Topical Report DPC-NE-2003, Revision 1

DUKE POWER COMPANY
OCONEE NUCLEAR STATION
CORE THERMAL-HYDRAULIC METHODOLOGY
USING VIPRE-01

Revision 1 Submitted: February 2000

Subject: Oconee Nuclear Station, Docket Numbers 50-269, -270, and -287
Topical Report EPC-NE-2003, "Core Thermal-Hydraulic Methodology
Using VIPRE-01"; Response To Request For Additional Information

FIGURE 1.

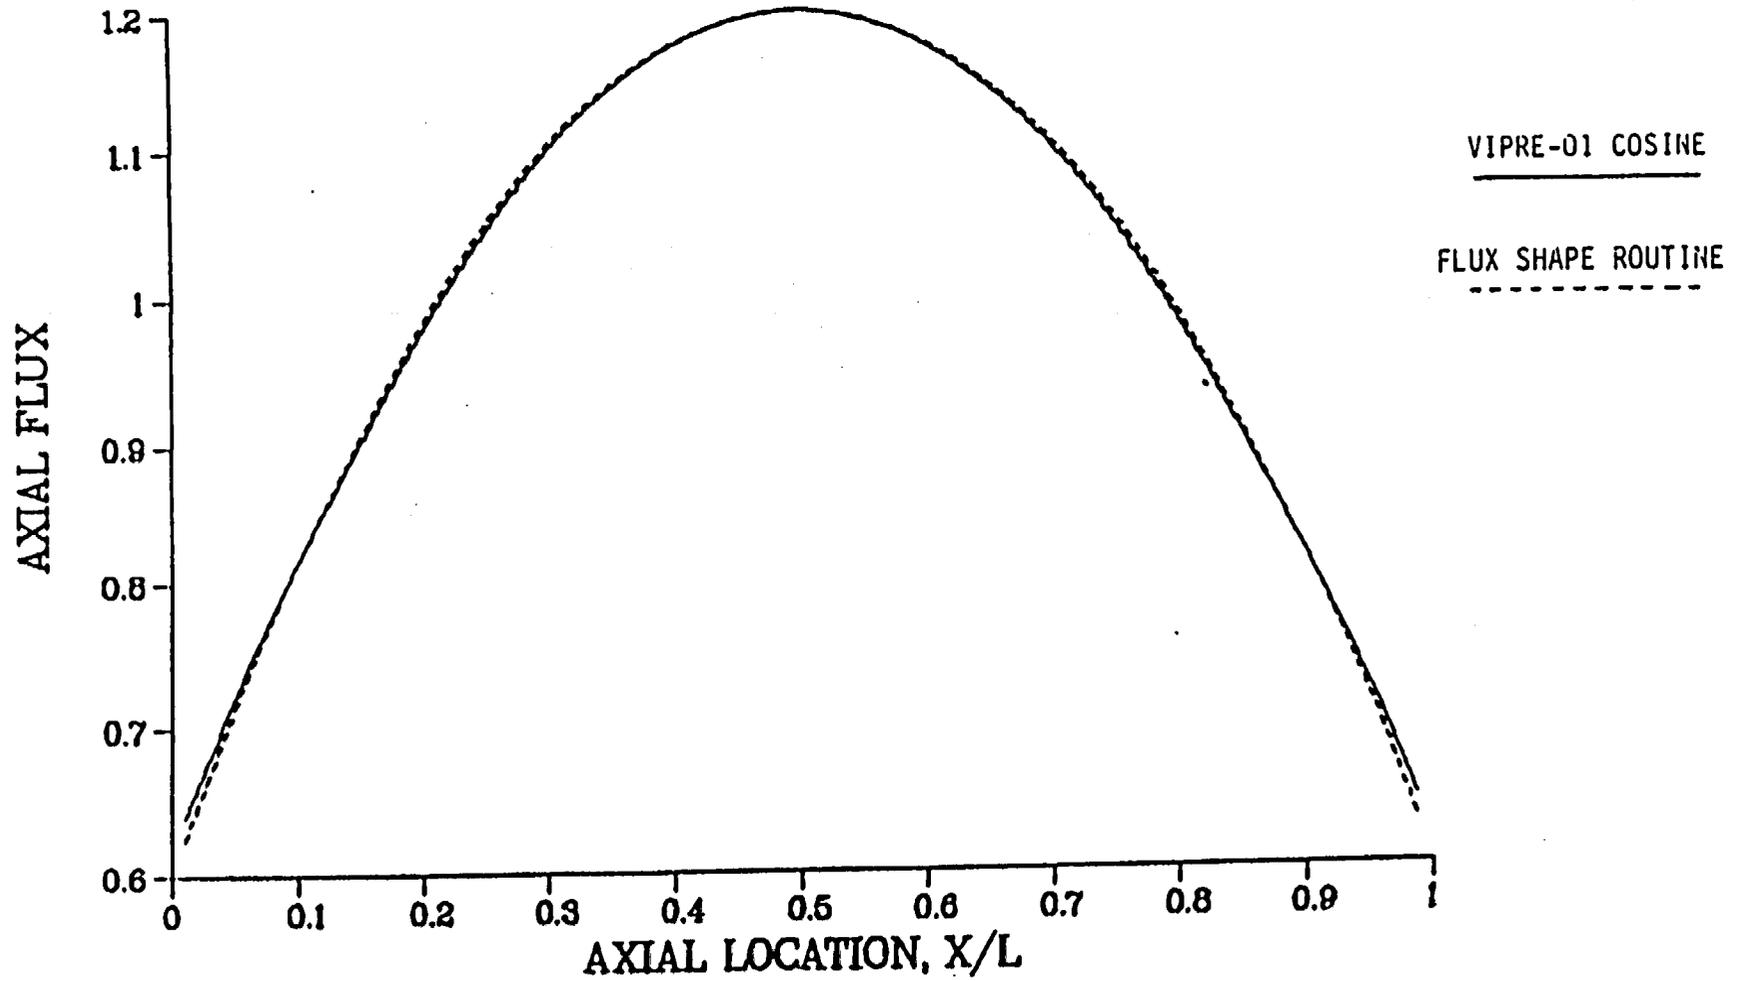
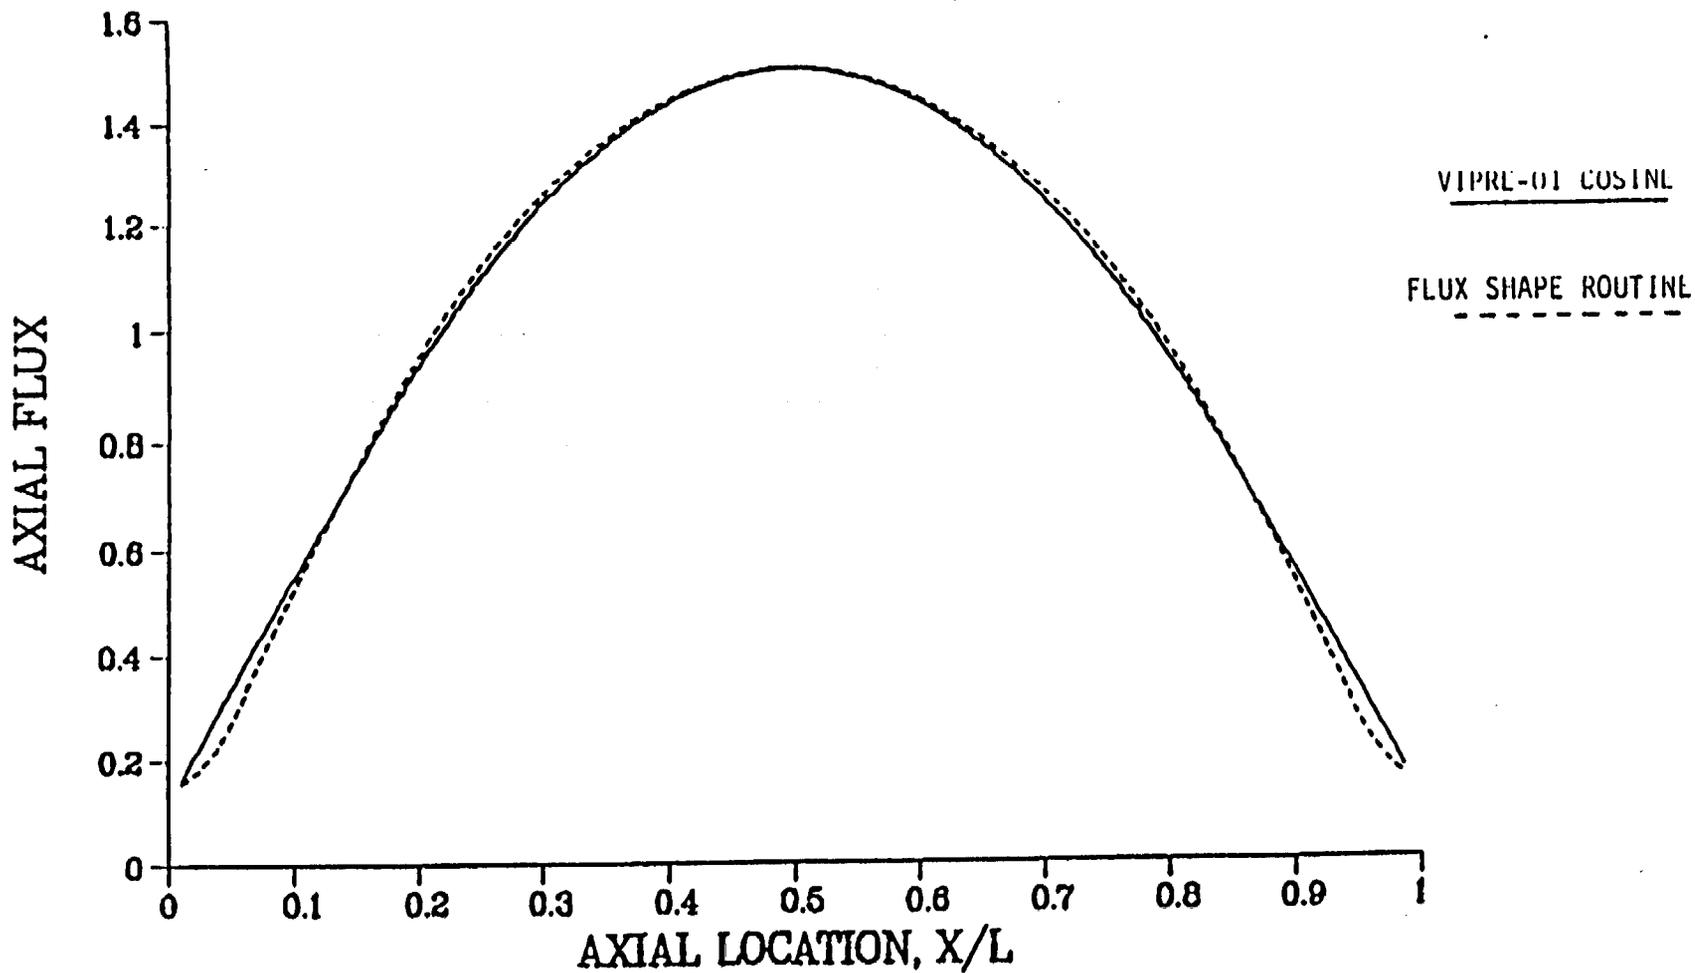
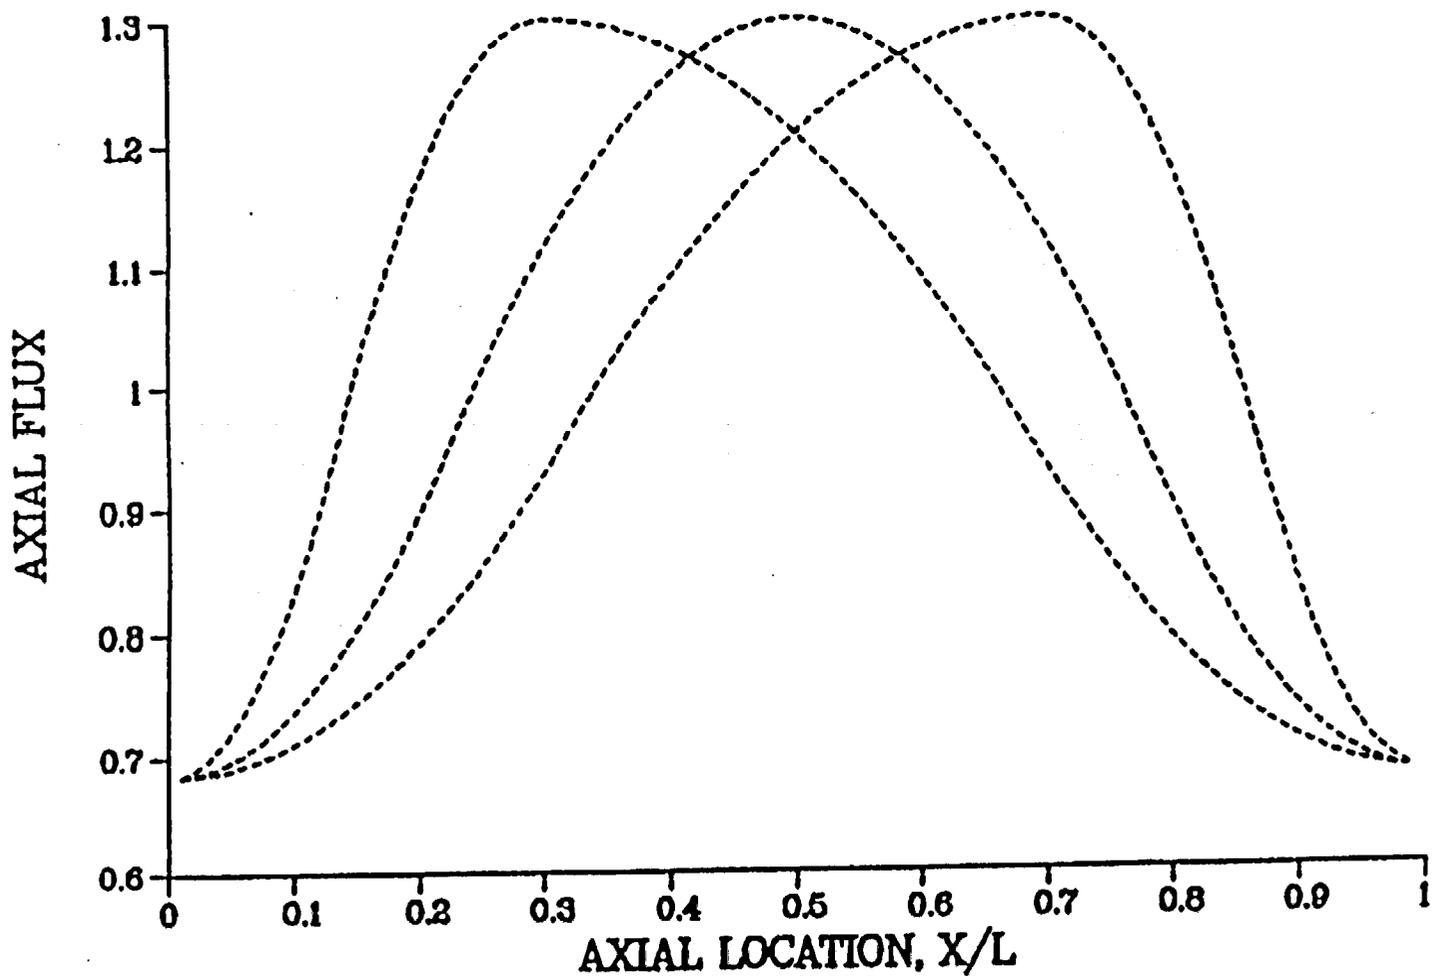
Section 5.10 states that a new routine is added to the VIPRE-01 code to generate axial power shapes with inlet, symmetric, or outlet peaks. Provide sufficient details of this routine.

The axial power shape routine added to VIPRE-01 is based on the following mathematical constraints on an axial power shape:

figures clearly show the agreement between the two methods of generating symmetric axial flux shapes. The new flux shape routine was added to generate skewed axial flux shapes. As discussed in Section 6.5 of the topical report, Maximum Allowable Peaking (MAP) limits are calculated for a range of axial peaks with the location of the peak varied from the bottom to the top of the core. As an example of the flux shapes used to calculate the MAP limits, three axial shapes are shown in Figure 3 for an axial peak of 1.3 at $X/L = 0.3, 0.5,$ and 0.7 .
